United States Patent and Trademark Office

DATE MAILED: 04/11/2006

APPLICATION NO.	FILING DATE	FIRST NAMED INVENTOR	ATTORNEY DOCKET NO.	CONFIRMATION NO.
10/608,048	06/27/2003	Robert A. Juran	APPL 2 13460	7920
7	590 04/11/2006		EXAM	INER
Thomas E. Young, Esq.			BOGART, MICHAEL G	
Fay, Sharpe, Fa	agan, Minnich & McKee,	LLP		
7th Floor			ART UNIT	PAPER NUMBER
1100 Superior Avenue			3761	
Cleveland, OH

DETAILED ACTION

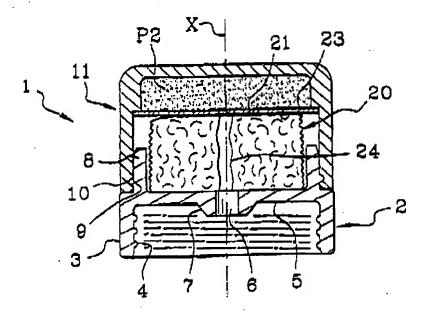
said skirt (46) being capable of surrounding and engaging the upper side wall (50) of an identical rigid applicator (10) whereby several applicators may be compactly stacked (see figure 6, below).

Regarding claims 18 and 27, the base wall (44) is integral with and effectively welded into the applicator body (12).

Regarding claims 21 and 28, the foam body (16) has a bottom surface (16d) adhered to said base wall (44)(column 3, lines 59-68).
